Re: Response to Review Comments  
Retreat at Prairie Ridge Preliminary Plan Phase 1  
El Paso, Colorado  
Entech Job No. 212381

Ref: Entech Engineering, Inc., revised date May 23, 2024. *Soils and Geology Study, Retreat at Prairie Ridge Filings 1, 2, and 3 – Preliminary Plan, Poco Road and Vollmer Road, El Paso County, Colorado.* Entech Job No. 212381.

Colorado Geological Survey, date May 6, 2024. *Review Comments by the Colorado Geological Survey, Retreat at Prairie Ridge Preliminary Plan Phase 1 (AKA Jaynes).* CGS Unique No. EP-24-0047\_2.

## Review Comments by the Colorado Geological Survey – 5/6/2024

JOB NO.  
212381  
 FIG. 1

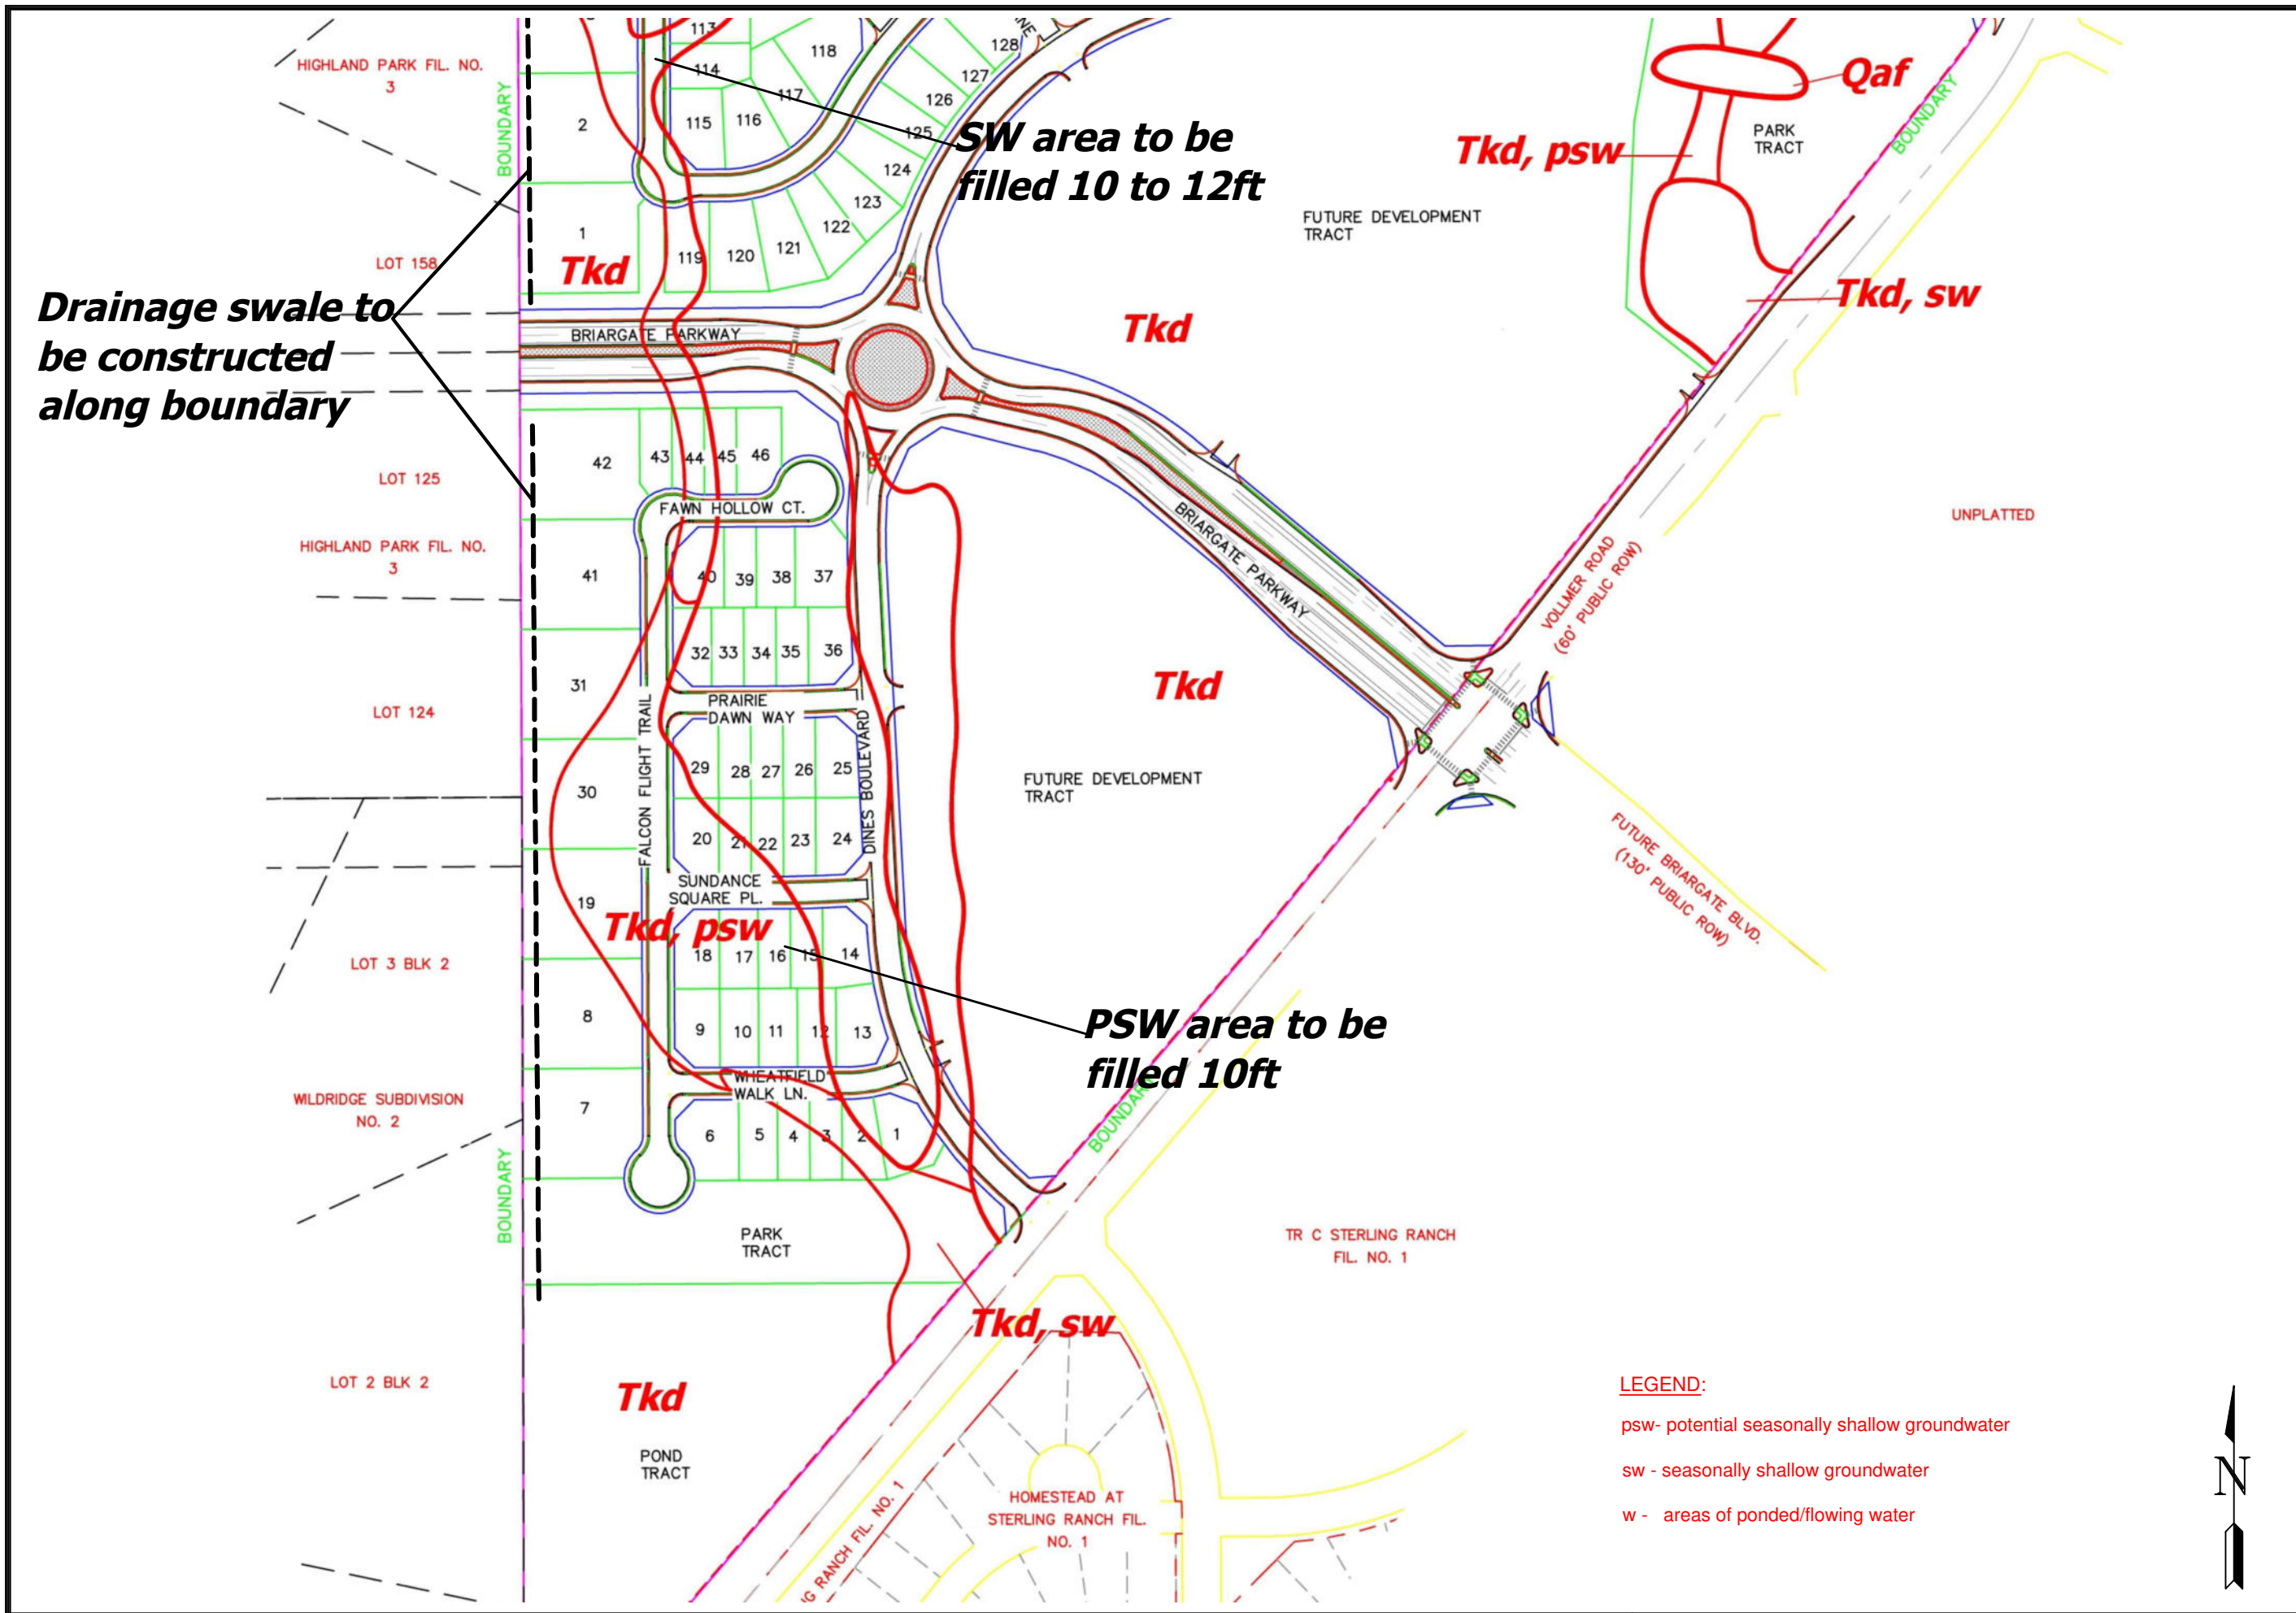
2. Test Boring 4, P2, P3, and P4 show groundwater at depths of 6.5 to 11.5 feet below grade. These areas are depicted as TKd (Dawson Formation) in Figure 8 of Entech’s report and Sheet 28 of the preliminary plan. These areas also contain potentially seasonally shallow groundwater (psw) or seasonally wet area (sw) and should be updated.

**Entech Response to Comment 2:** Test Boring 4 (TB-4) is located in the large lot (5-acre) area. Additional investigation on each of the large, rural lots will be required prior to construction. Piezometers P2 and P4 are located in areas to be filled. After grading, the water depths are expected to be 23 and 17 feet. These areas should be suitable for basement construction. Piezometer 3 (P3) is located along the roadway alignment and not in an area of residential lots.
